**> New PRETREATmaker Filter for Version III and IV**

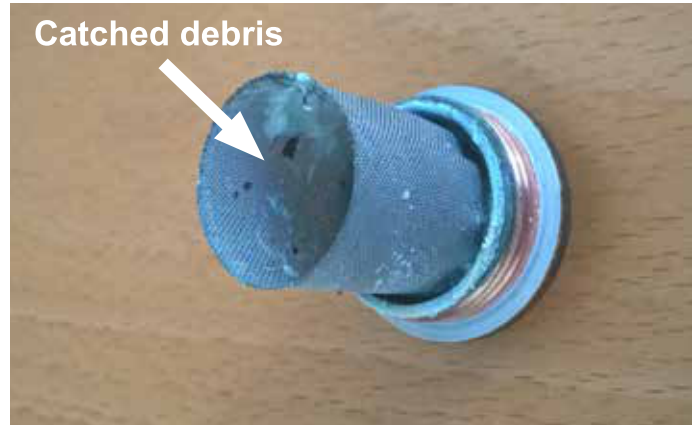
**• Problem:**

The 4 nozzles in the **PTM3** can easily get clogged when there is some debris in the pretreatment solution because dust might get into the pretreatment tank. This will lead to an uneven layer of PT on top of the garment and as a result a bad printout.

In the **PTM4** a new filter has been introduced to catch possible debris in the tubes before it reaches the nozzles and cause some clogage.

**• Solution:**

Adding the new filter to the machine will clean the Pre-Treatment line and will prevent clogging the nozzles.

This filter can be added in the **PTM3** as well.

SPARE PARTS NO. 807056

SPARE PARTS NO. 807057
